**Town of Nags Head Planning Board
Nags Head Municipal Complex Board Room
Tuesday, September 17th, 2024; 9:00 a.m.**

MEMORANDUM

Subject: Special Use Permit/Site Plan Review, 425 W. Health Center Drive

Purpose/Request: Construction of an approximately 3,460 square feet, two story, eight-bedroom dormitory (duplex) and all associated site improvements. This dormitory is for use by Town of Nags Head workforce or as approved by the Town Manager.

SITE, UTILITY & LANDSCAPING PLAN

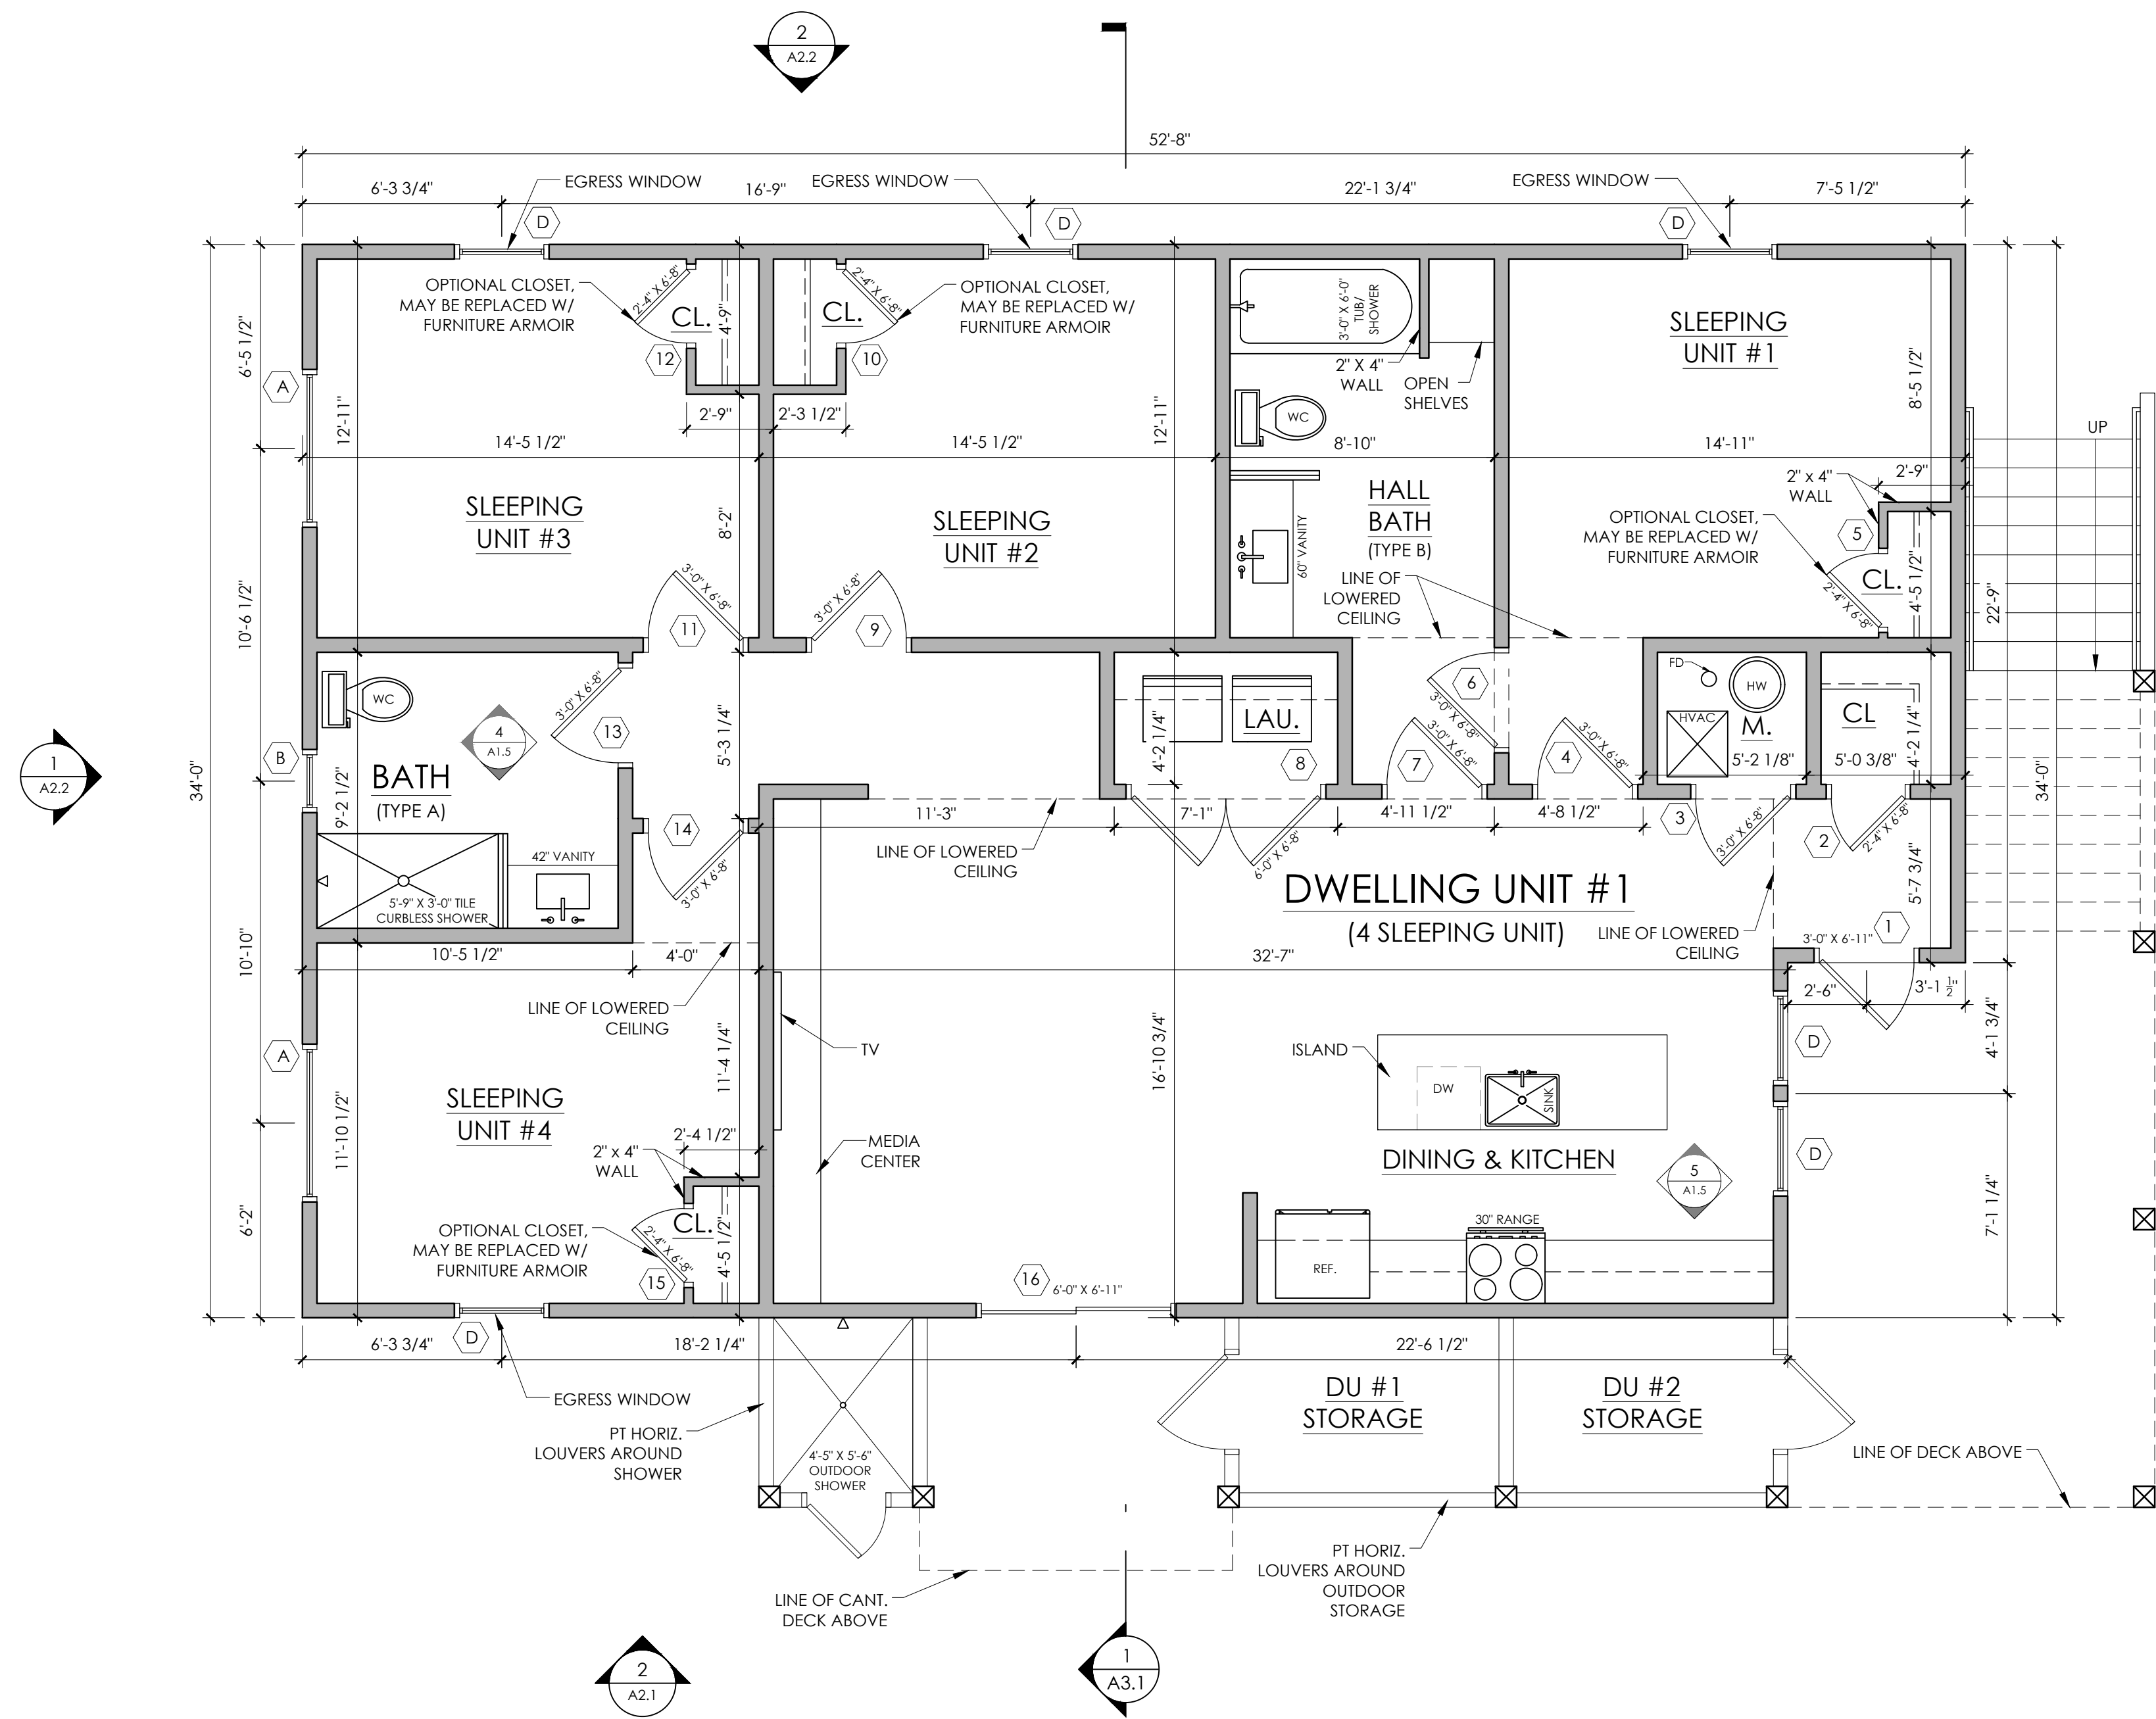
The proposed redevelopment of the dormitory, including the removal of the non-functional helipad and various other improvements, conceptually shows a lot coverage of 29.03%, slightly above the allowable 28.6%. However, we are awaiting an opinion from our town attorney regarding the correct boundary of the property. It is likely that once the property boundaries are confirmed, the total lot area will increase, which would reduce the lot coverage percentage to 28.6% or less. Please note the discrepancy between the property boundaries shown in Dare County records versus those on the survey (attached). This conflict will be resolved before the Board of Commissioners reviews the project, and the property will not be deemed compliant until the lot coverage is confirmed to be 28.6% or less of the total lot area

Currently, there are 37 existing parking spaces onsite. Based on a liberal application of the medical office parking standard to the Community Care Clinic, which is also located onsite, we estimate that approximately 25 parking spaces are necessary for the clinic. This leaves 12 parking spaces available for dormitory use, providing parking for three-quarters of the dormitory occupants. Ideally, 16 spaces—one per occupant—would be available for this use.

Staff is requesting that the Planning Board consider applying this shared parking provision to address the four (4) additional parking spaces needed to meet the desired total of 16 spaces for the dormitory. The Community Care Clinic operates between 9:00 AM and 4:00 PM, Monday through Friday, and is closed on weekends. In contrast, the Town's ocean rescue staff typically works from 9:00 AM to 6:00 PM, with some early morning training sessions. Given these staggered hours, there should be minimal overlap in parking demand between the clinic and the ocean rescue staff.

Based upon staff's review of the proposal, we recommend approval of the Special Use Permit/Site Plan Review as submitted conditioned upon the proposed lot coverage not exceeding 28.6%.

DRAWING NAME:
**EXTERIOR
ELEVATIONS**

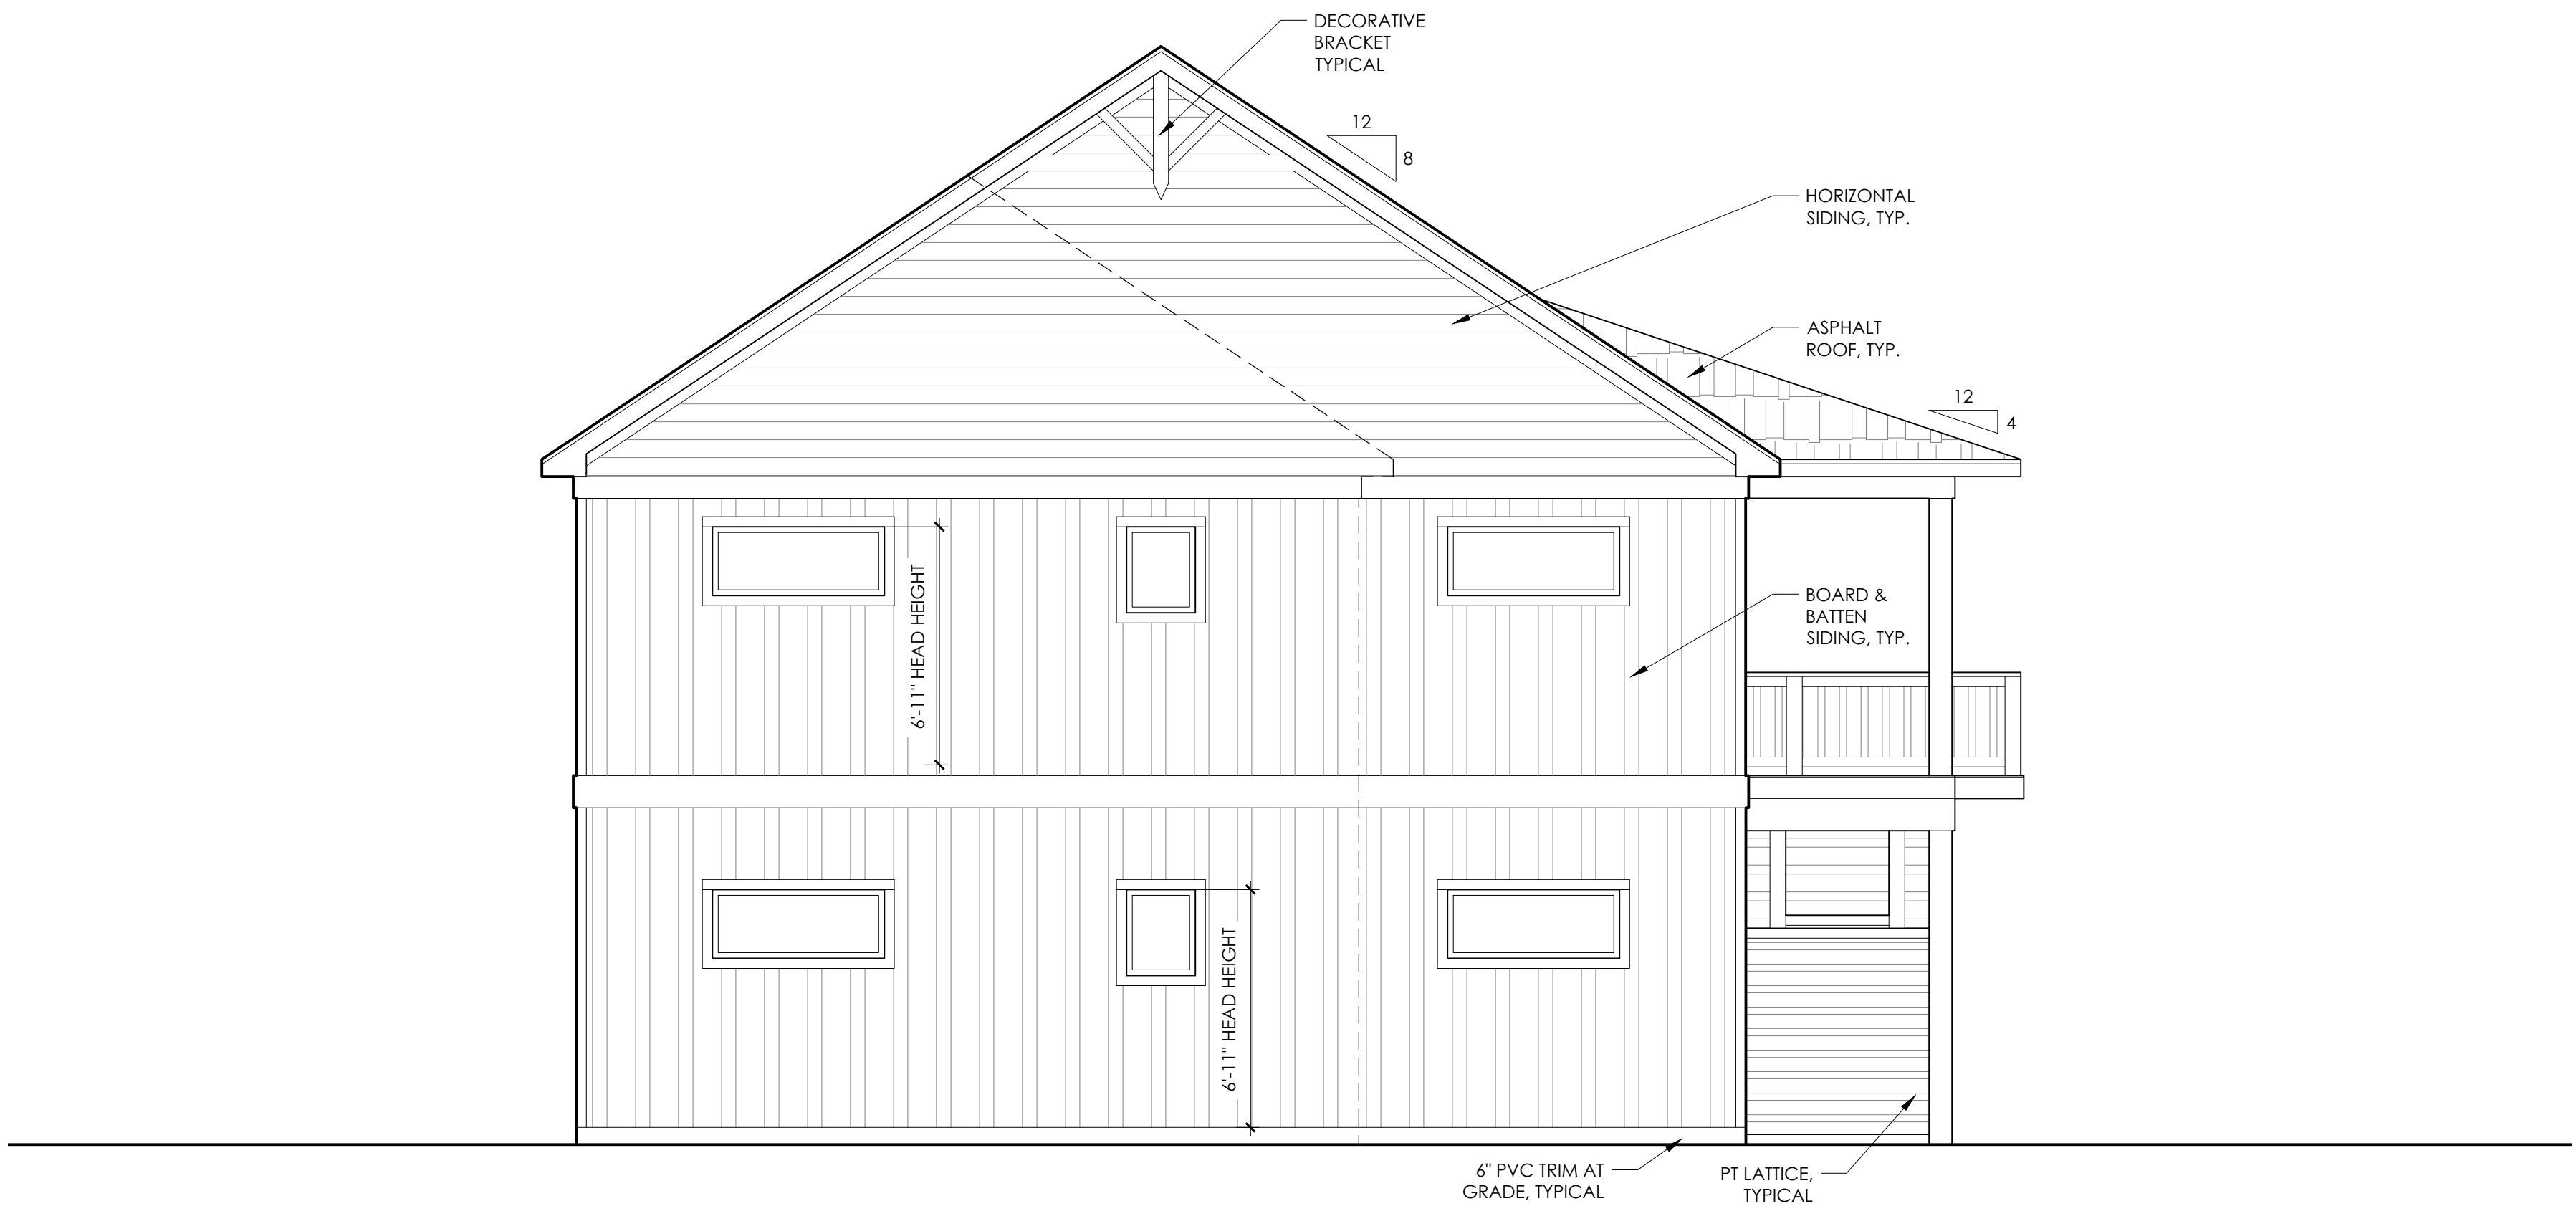
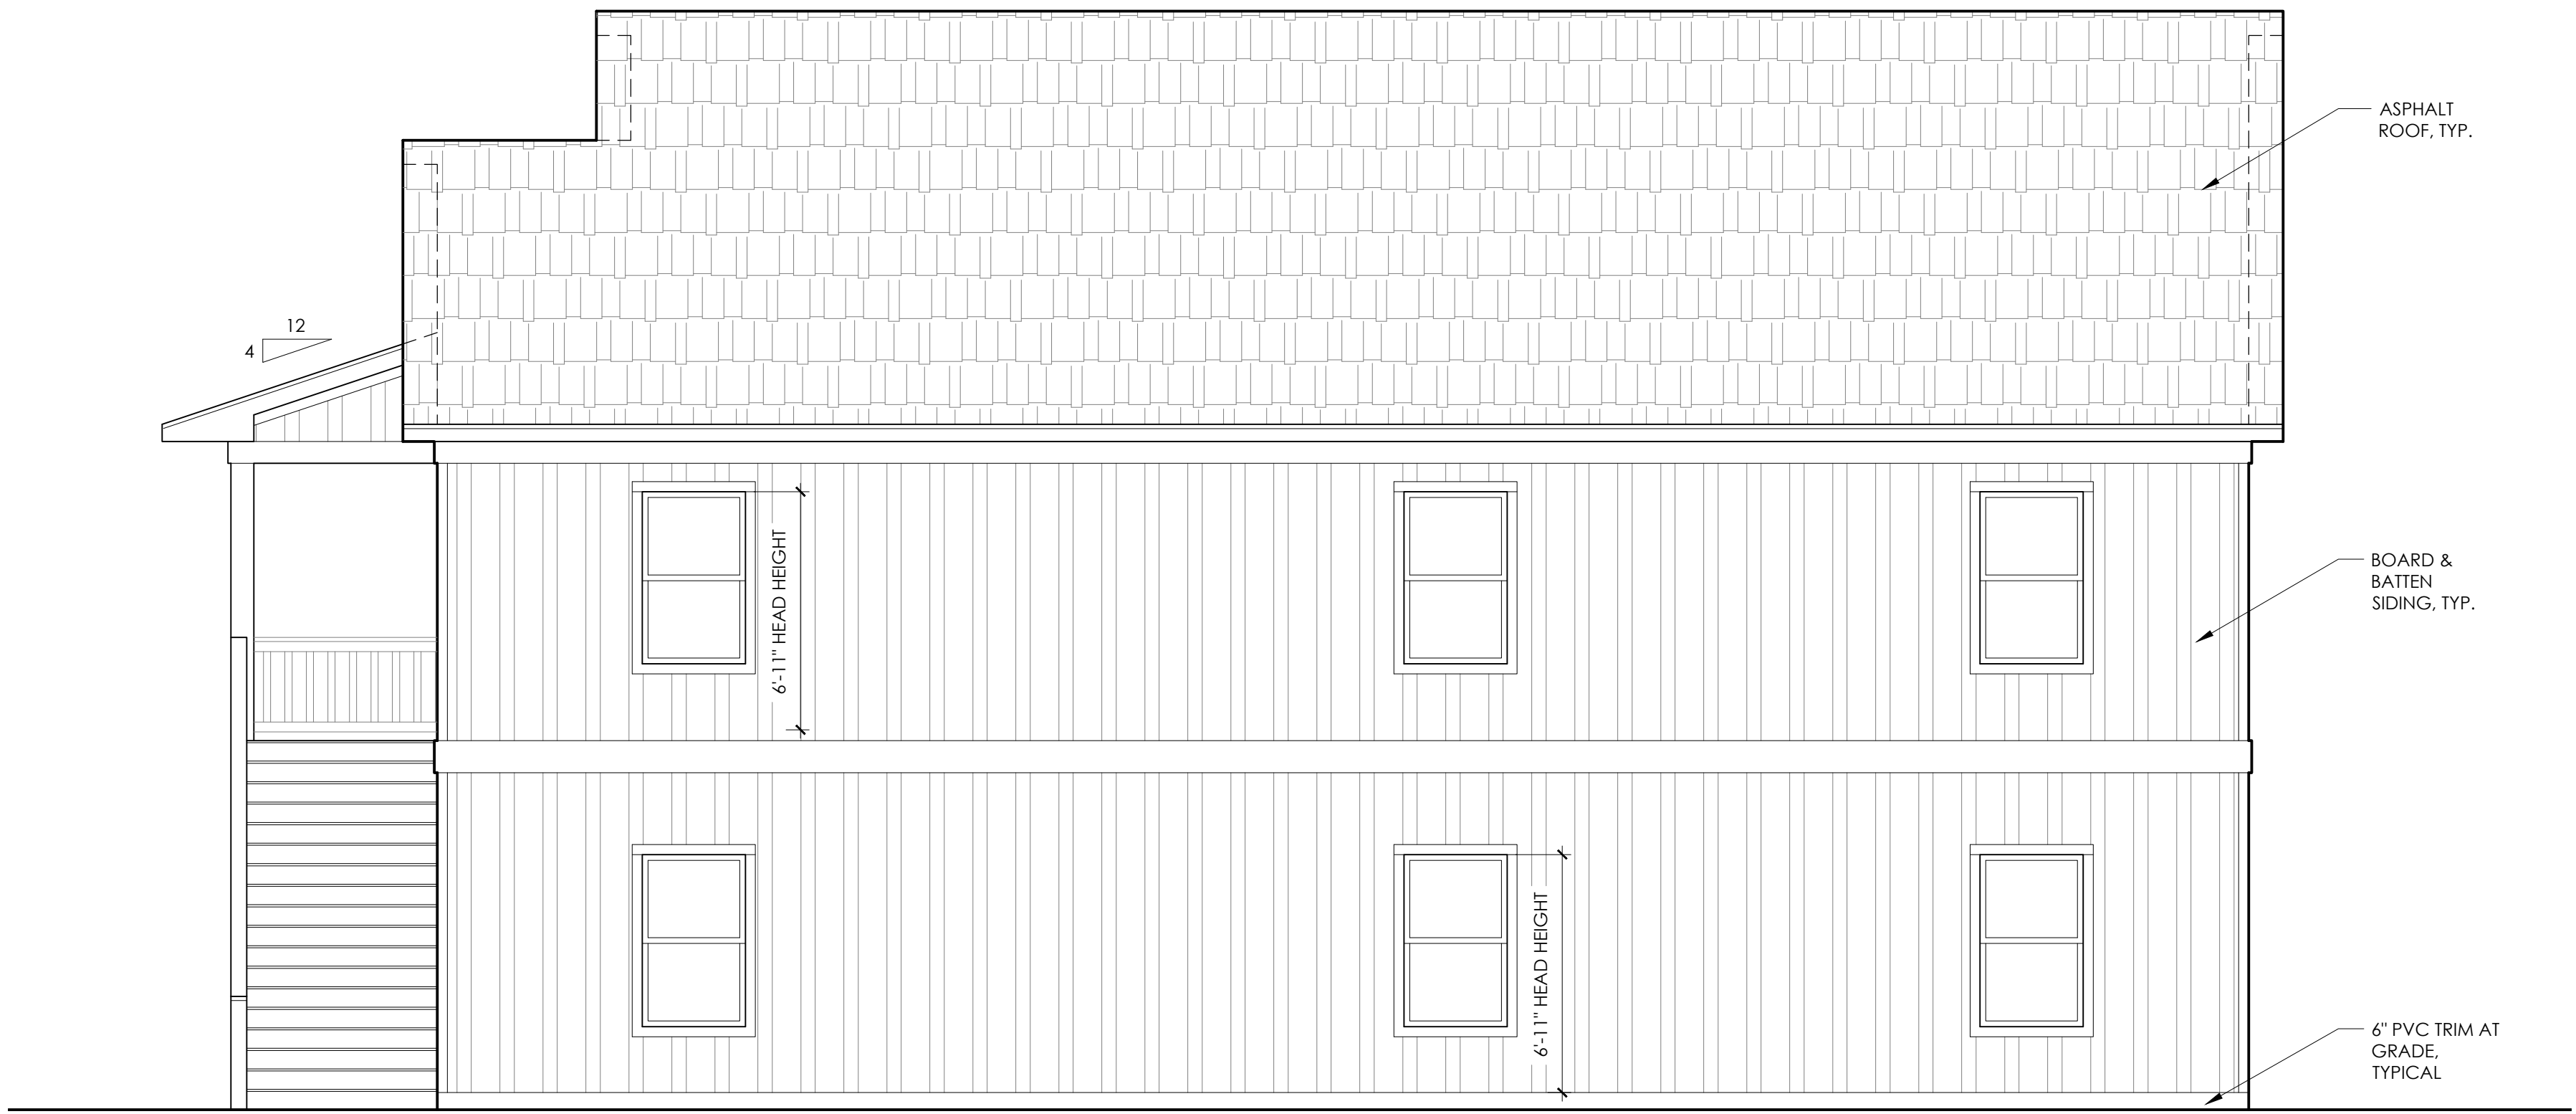
- Architecture Design Standards: Section 10.82 of the UDO, Applicability, states that Commercial Design Standards shall apply to all building construction or remodeling projects requiring a special use permit or site plan review. This project must adhere to the Commercial Design Standards set forth within Part VI of the UDO. As proposed this project will comply with standards set forth in Division II – Building Design including a human scale design with a second-floor covered porch, residential style single or double hung windows, board and batten siding, gable brackets, etc. We have requested that the architect incorporate a few other elements such as workable shutters and column trim.
